**City Planning Commission
Meeting – February 10, 2015**

CONSIDERATION – SUBDIVISION DOCKET 175/14

Applicant: Joseph S. Mann, Jr. and Dorothy Sarpy Mann

Proposal: Resubdivision of Lots 7-A and C into proposed Lots 7-A-1 and C-1.

Resubdivision Of Lots 7-A & C, Into Lots
 7-A-1 & C-1, Sq. 247, Sixth District,
 Rickerville, New Orleans, Orleans Parish, La.

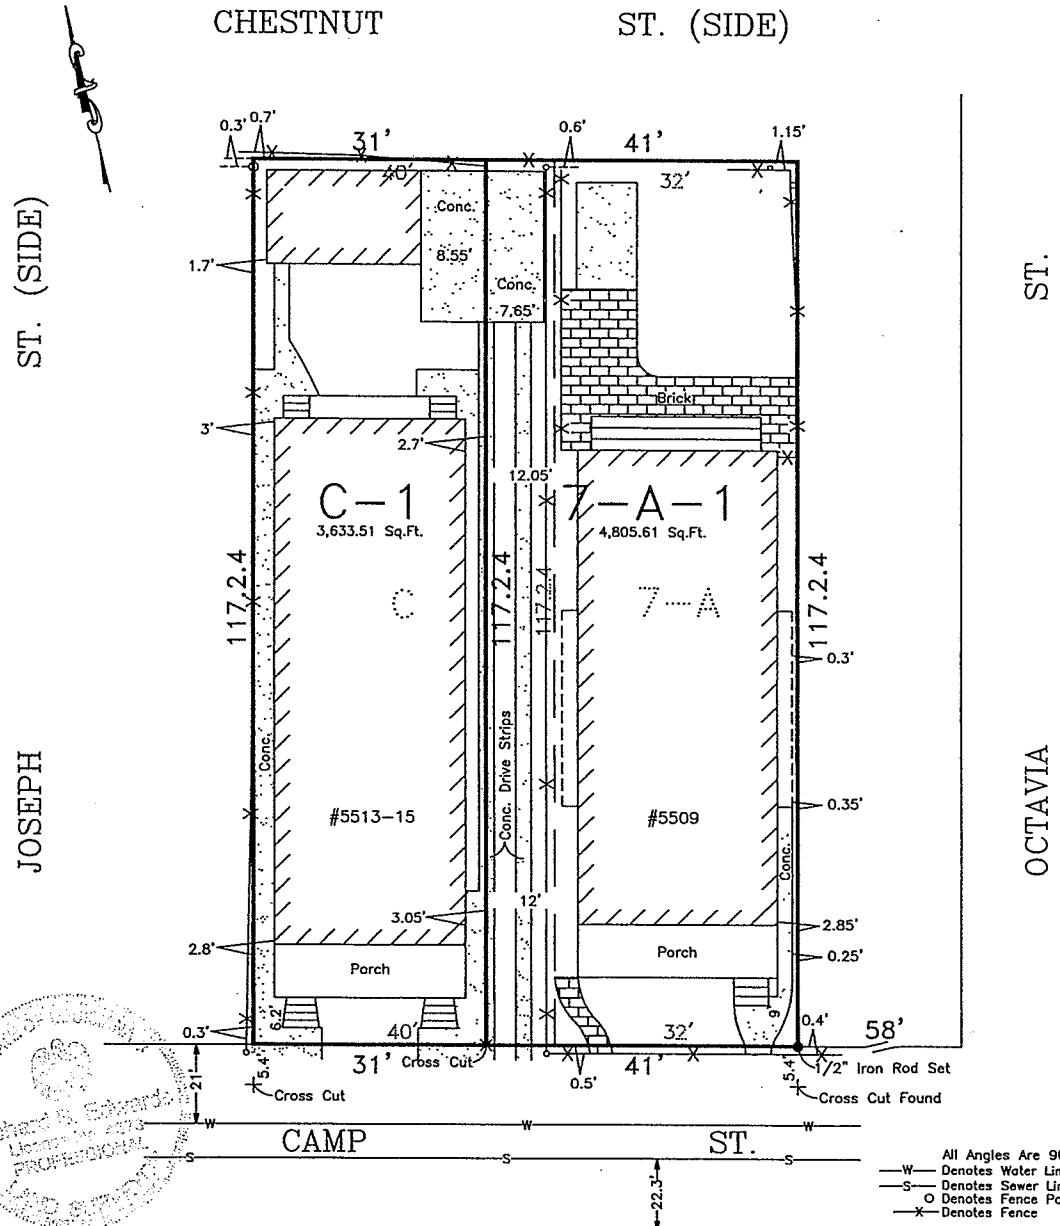
The Department of Safety and Permits objects to the subdivision as proposed because the setback of 5513-15 Camp Street from the new common lot line would be less than 3 feet at the rear of the lot, violating the RD-3 District's minimum setback requirement. The representative of the Department of Safety and Permits indicates that its objection could be resolved if the setback is altered to comply with the 3 foot requirement.

The Sewerage and Water Board stated that sewer and water facilities and subsurface drainage are available for the proposed lots. It also noted that sewer and water house connections are available but not shown on the re-subdivision survey and so a note should be shown on the survey indicating that sewer and water house connections are the responsibility of the property owner.

Aside from the parking issue, the re-subdivision also proposes a setback deficiency for Lot C-1 that the staff believes that applicant should resolve by making a minor change to the location of the proposed common lot line. As proposed, the re-subdivision would result in 5513-15 Camp Street having a side yard setback from the common lot line that is less than 3 feet at the rear of the structure. This is objectionable because it violates the RD-3 District’s requirement in **Article 4, Section 4.6.7** and **Table 4.F** that side yard setbacks be at least 3 feet each. Additionally, since that structure’s other side yard setback is only 2.8 feet, which is grandfathered, the aggregate side yard (i.e., the combined width of the two side yards) would be only 17.7% of the lot’s width at 5.5 feet, substandard of the RD-3 District’s requirement that aggregate side yards be at least 20% of the lot’s width.

- The applicant shall shift the common property line between proposed Lots 7-A-1 and C-1 so that 5513-15 Camp Street has an Octavia Street-side yard that is at least 3 feet and an aggregate side yard that is at least 20% of the width of proposed Lot C-1.

Finally, if the subdivision is approved, it would be necessary for the proposed lots' designation as 7-A-1 and C-1 to be changed to 7A1 and C1. The inclusion of dashes in lot designations is problematic for technical reasons related to computer software. It would therefore be necessary for these dashes to be eliminated.

- The designations of the proposed lots as Lots 7-A-1 and C-1 shall be altered to Lots 7A1 and C1.

These problems can be resolved by simply modifying the common's lot line so that it is about 3.5 feet from 5513-15 Camp Street and so that the aggregate side yard is at least 20% of lot's width. That would cause both the side yard and aggregate side yard requirements to be met. Therefore, if the subdivision is granted tentative approval, final approval should be subject to the following proviso:
